AGENDA - TROY PLANNING COMMISSION MEETING
WEDNESDAY, SEPTEMBER 23, 2026, 3:30 P.M.
CITY HALL, COUNCIL CHAMBERS

HISTORIC DISTRICT APPLICATION – CERTIFICATE OF APPROPRIATENESS, 111 W. WATER STREET, FOR INSTALLATION OF BUILDING SIGNS; OWNER – RANDY KIMMELL; APPLICANT – THE MT STUDIO, LLC, MICHAEL TWISS. Staff reported: Property was constructed in 1863 and is not on the National Register of Historic Places; building is permitted 150 square feet of building signage; application is for two signs of individual mounted letters; 54 sq. ft with red lettering mounted directly into the sign backer on the west faced; 84 sq. ft on the front façade, facing Water Street; for a total of 138 sq. ft.; the red color is Sherwin Williams Real Red 6868. Staff noted that the signs have been installed without the applicant seeking a Certificate of Appropriateness, so the applicant had to pay double the permit fee. Staff recommended approval based on:

SUBJECT: Historic District Review – 111 W. Water Street

Rehab Project for:
RUDY'S SMOKEHOUSE
111W. WATER STREET TROY, OH 45373
MT STUDIO PROJECT NUMBER: 34094

EXTERIOR ELEVATIONS

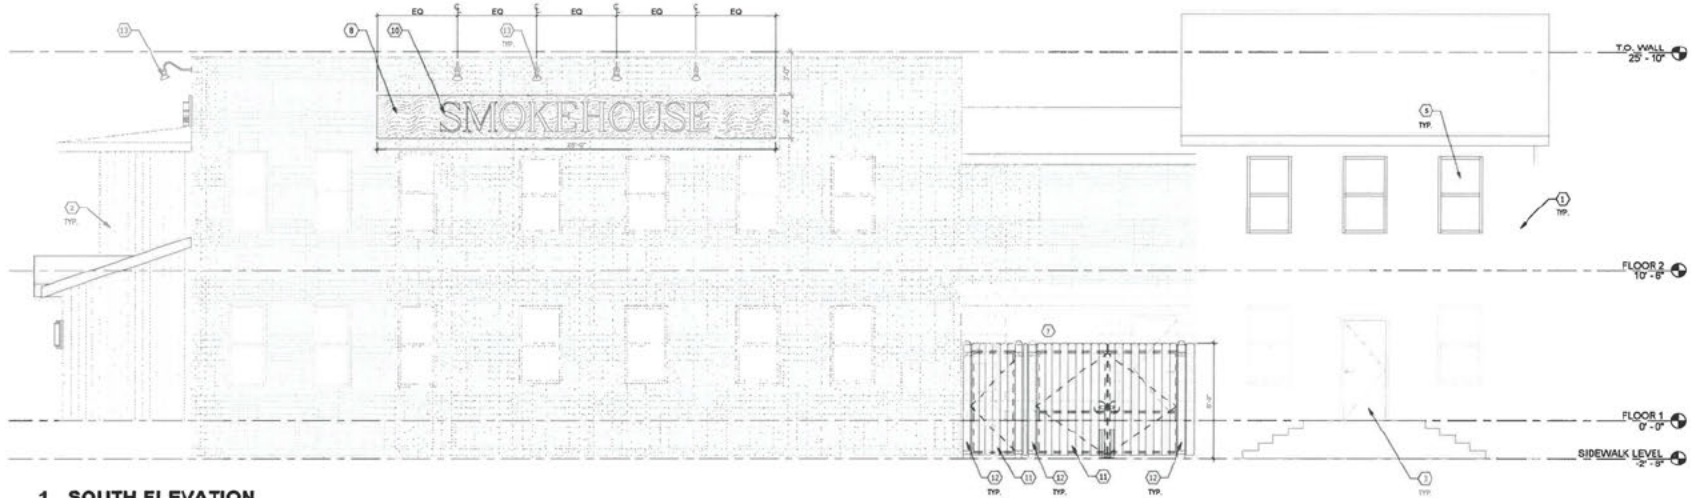
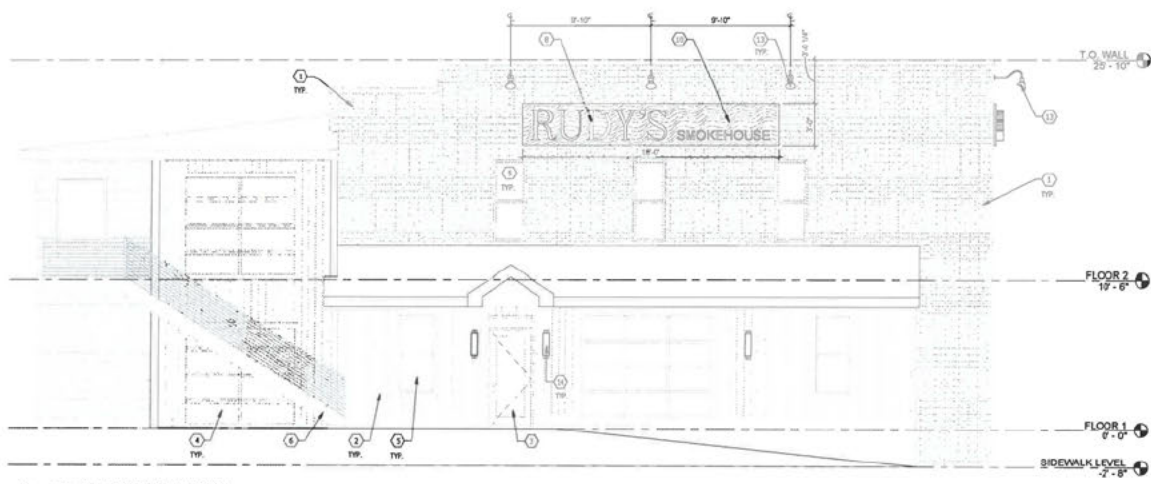
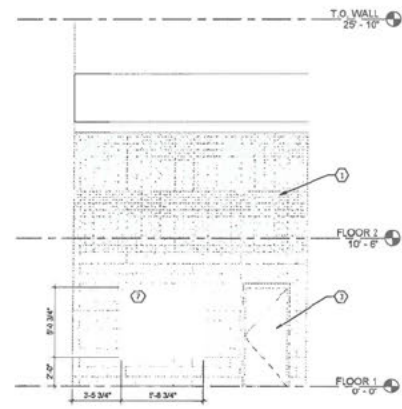
DISCUSSION: Mayor Oda commented that there was a third sign facing the parking lot that reads Bar B Q. Staff was asked to check the building and determine if a third sign has been placed and, if so, is the total square feet of signage still within the allowed signage.

This building is permitted to have a total of 150 square feet of building signage. The applicant is proposing to install the maximum allowance of 150 square feet with three (3) sets of individual mounted lettering. On the West façade, there will be two signs: one totaling 12 square feet with red lettering, and the other is 54 square feet with red lettering mounted directly to a sign backer. On the front façade (facing Water Street), there will be an 84 square foot sign with red lettering mounted directly to a sign backer. It is important to note that the signs have already been installed without a COA from the Planning Commission (see attached photos).

The Design Manual section 5.4 states, "Wall signs should be three dimensional, with letters carved by a router, or; letters should be individually pin-mounted or incorporated into a sign panel". The proposed building signage will meet section 5.4 of the Design Manual.

ACTION OF THE COMMISSION. A motion was made by Mr. Wolke, seconded by Mr. Titterington, to table the application for 111 W. Water Street so that the third sign could be checked and, if it has been placed, staff speak with the applicant.

- The proposed sign will meet the City of Troy Sign Code requirements;
- The proposed sign complies with section 5.4 of the Design Manual.
